**ROCKFORD BOARD OF EDUCATION  
INVITATION FOR BID ON SUPPLIES, MATERIALS, EQUIPMENT OR SERVICES  
FOR SCHOOL DISTRICT NO. 205  
ROCKFORD, ILLINOIS**

**IFB No. 17-11 Bloom Elementary School Cafeteria Addition and Renovation**

**RE: ADDENDUM NO. 1**

Project: **17-11 Bloom Elementary School Cafeteria Addition & Renovation**  
Project Number: IFB No. 17-11

SHEET NO.  
FS101

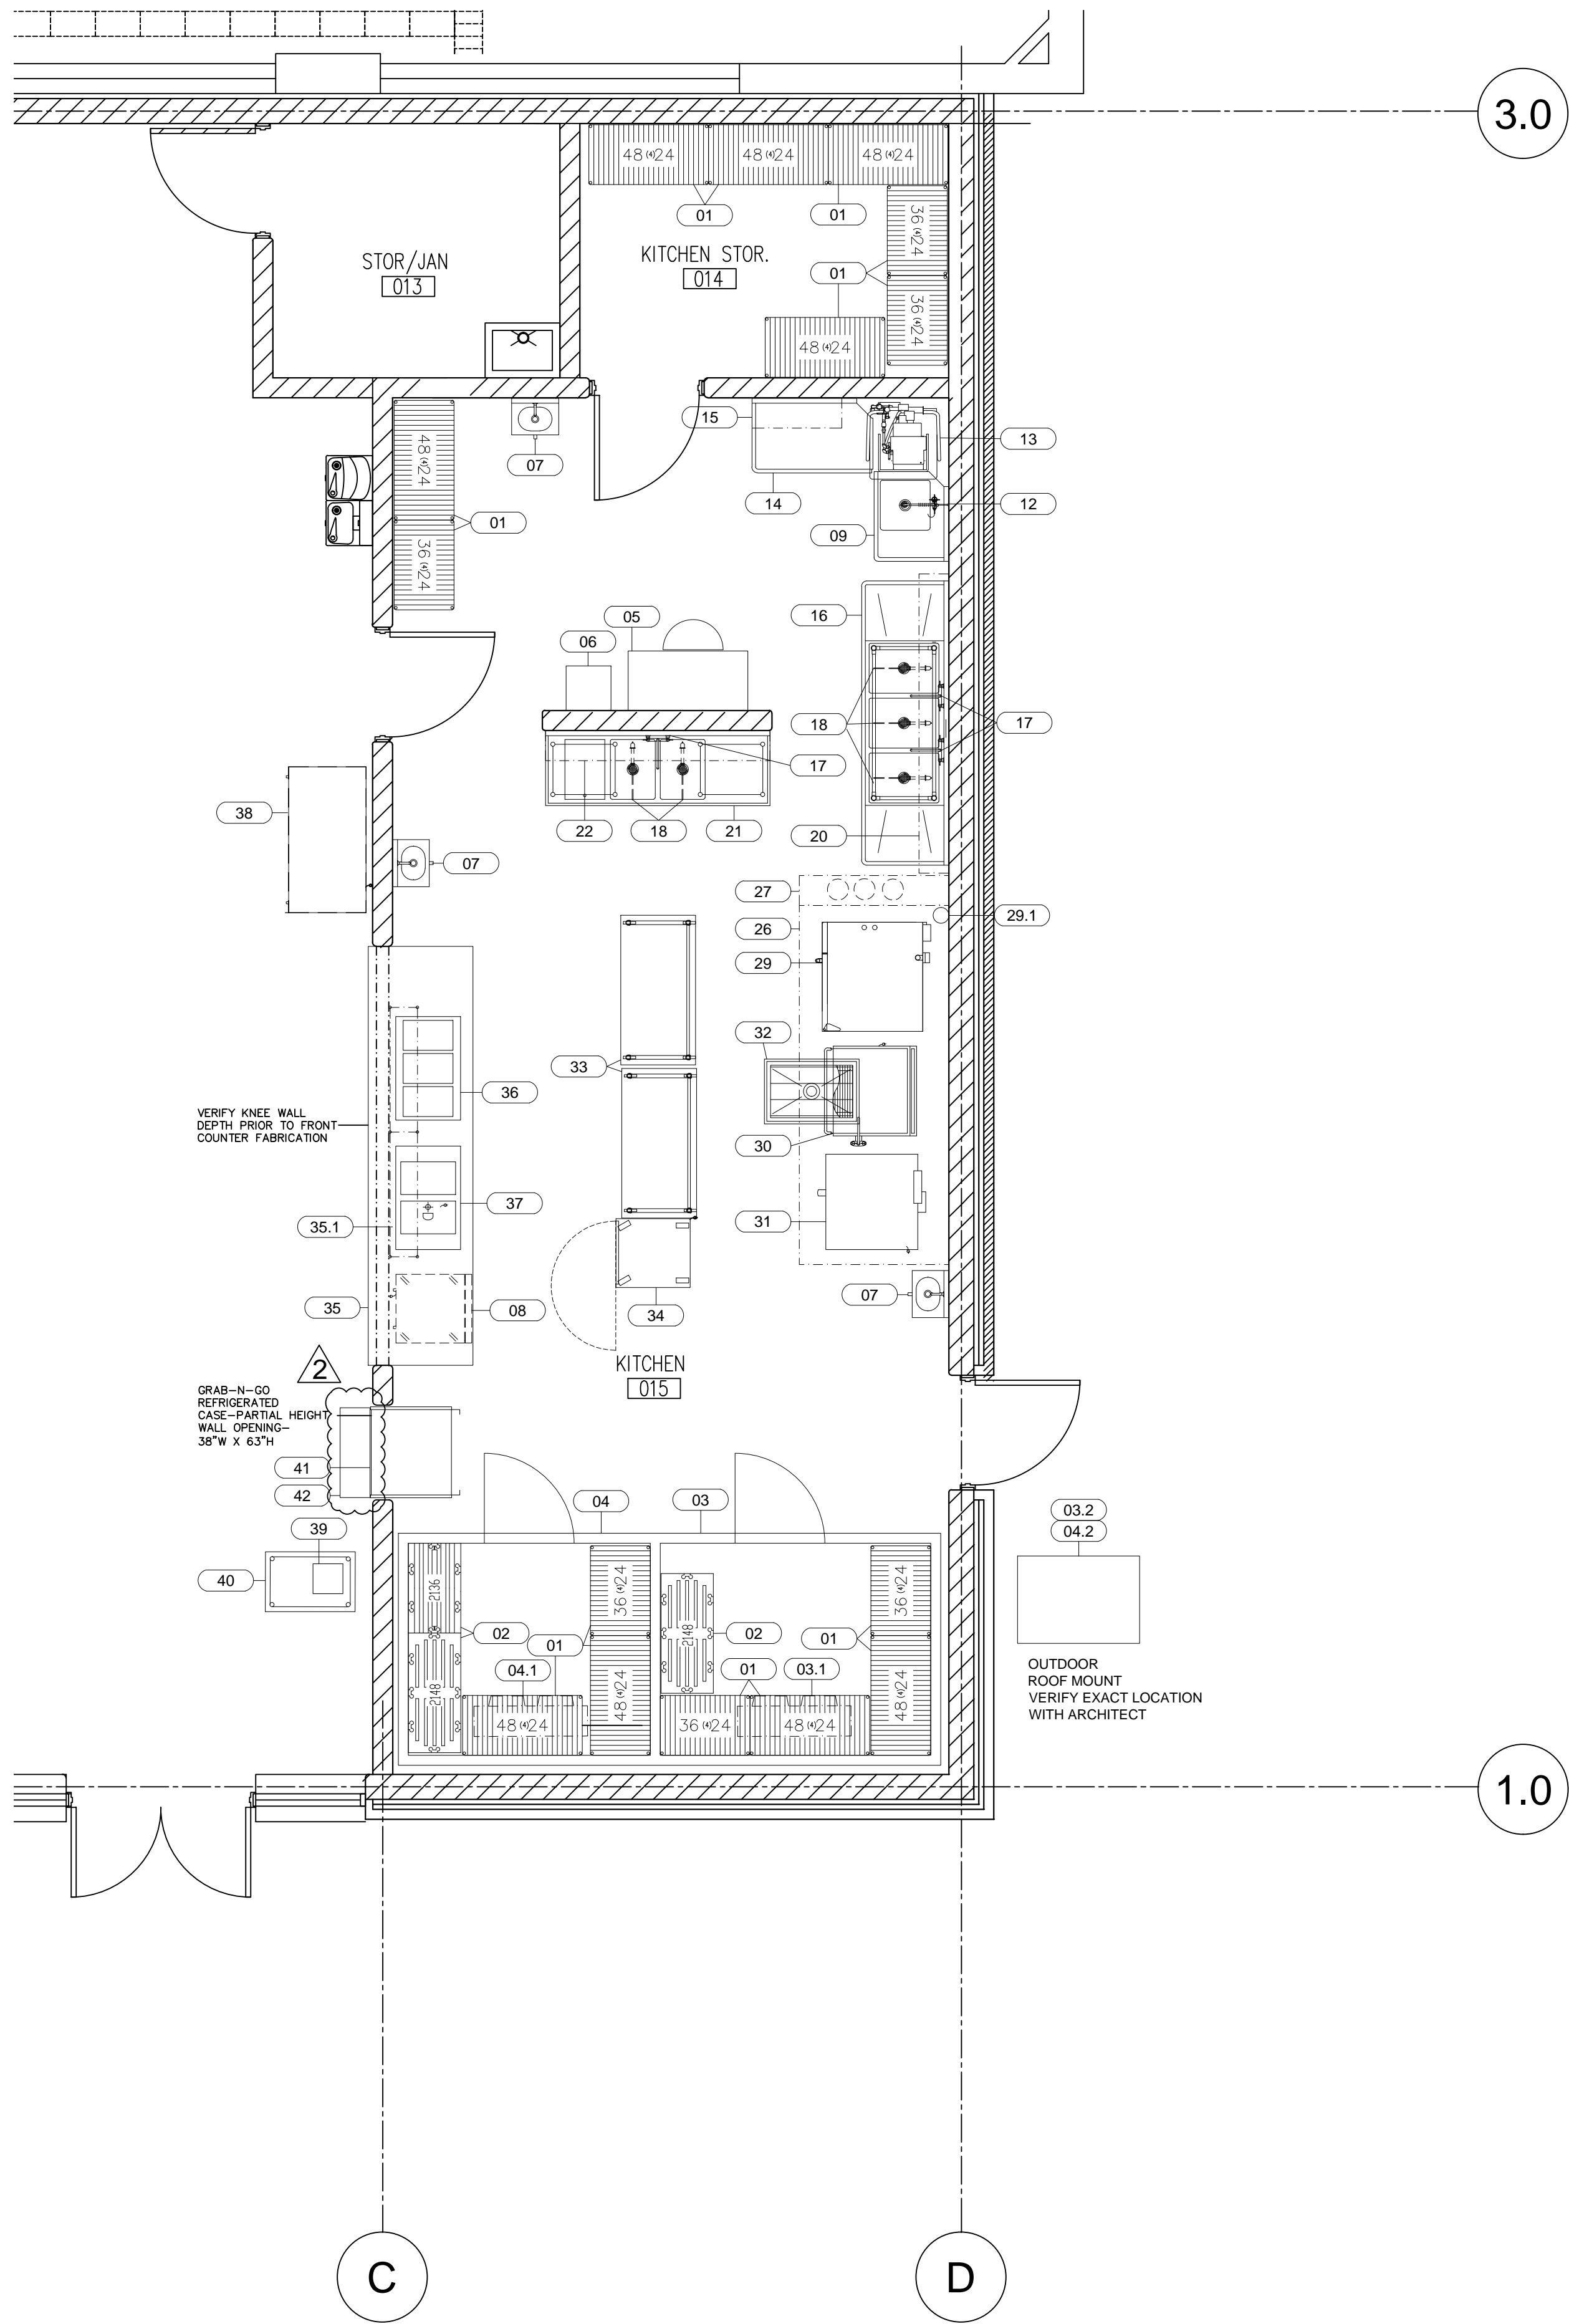
- 1. Sheet M3.00 Mechanical Schedules ( See attached sheet )
- 2. S2O - Sheet FS101 dated 09-12-2016 ( See attached sheet )
- 3. S2O - Sheet FS101E dated 09-12-2016 ( See attached sheet )
- 4. S2O – Sheet FS101M dated 09-12-2016 ( See attached sheet )
- 5. S2O – Sheet FS103C dated 09-12-2016 ( See attached sheet )

- a) Section 114000 – Foodservice Equipment dated 09-12-2016
- b) S2O - Sheet FS101 dated 09-12-2016 ( See attached sheet )
- c) S2O - SheetFS101E dated 09-12-2016 ( See attached sheet )
- d) S2O – Sheet FS101M dated 09-12-2016 ( See attached sheet )
- e) S2O – Sheet FS103C dated 09-12-2016 ( See attached sheet )
